To: All Parties on Record with the City of Somerville as Holding **IFB 15-105-Rebid**
USQ Utility and Roadway Construction

Re: Change in Specification, New Unit Price Form

Addendum No. 3 to IFB 15-105-Rebid

City of Somerville
Union Square Utility and Roadway Early Action Project
IFB# 15-105-Rebid

SHEET
C-31

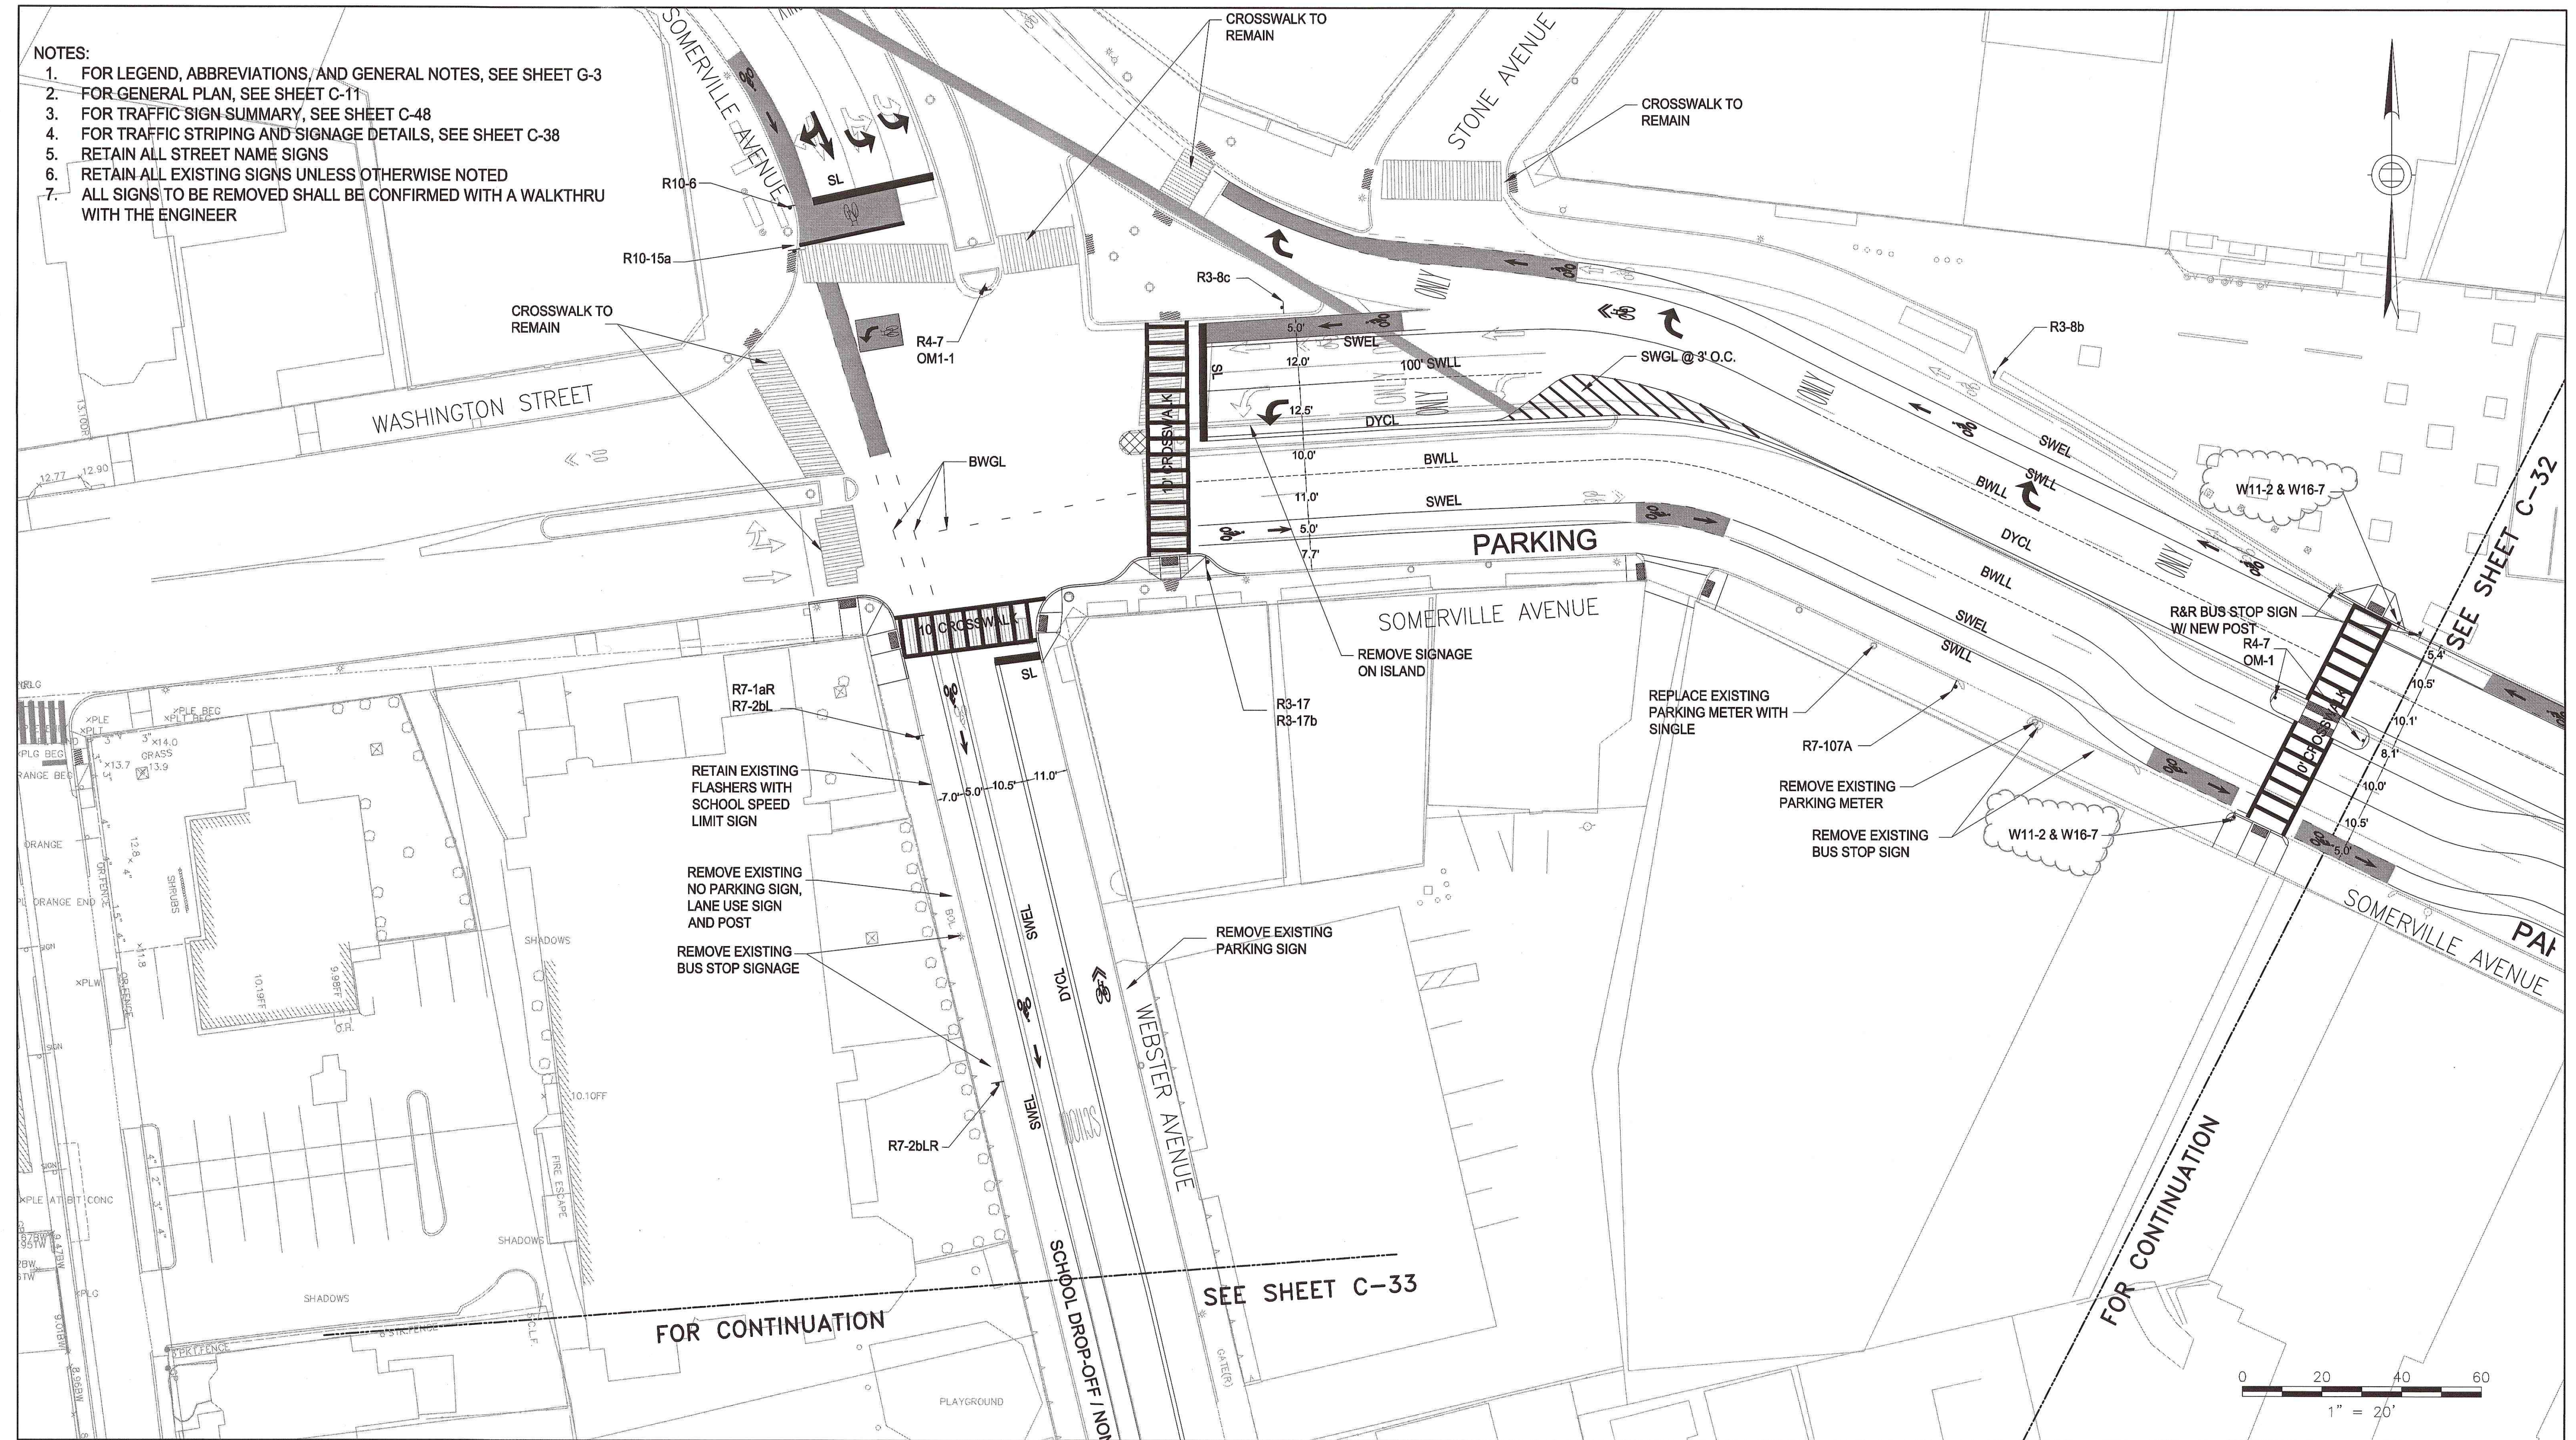
8. Drawings – Sheet C-31

DELETE Sheet C-31 in its entirety and **REPLACE** with Sheet C-31, Rev. 1, included as Attachment 3 to this Addendum No. 3.

NO.	DATE	REVISIONS	BY
1	1/26/16	DELETED RRFB
